# Access Compliance Report

## Public Rights-of-Way

### (Curb Ramps)

| Intersection ID: 24855 | Main Street: MACANDREW_DR | Cross Street: TWYNHAM_LN | Location: E            |

| ADA ID: BF9BFA6AEFDF   | Ramp Type: PerpDiag       | Initial Pass/Fail: Fail  | Overall Compliance: No |

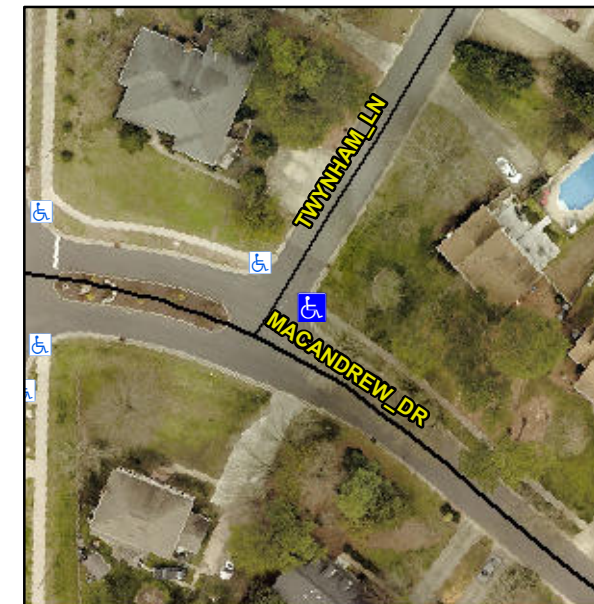
**Not Found, R304.5.1, R304.5.3**

| Compliance | Description           | Data  | Compliance | Description                 | Data  |
|------------|-----------------------|-------|------------|-----------------------------|-------|
| No         | Ramp Width (in)       | 44.0  | No         | Ramp XSlope (%)             | 2.7   |

**Remove & Replace Curb Ramp With Two New Directional Ramps or Equivalent.**
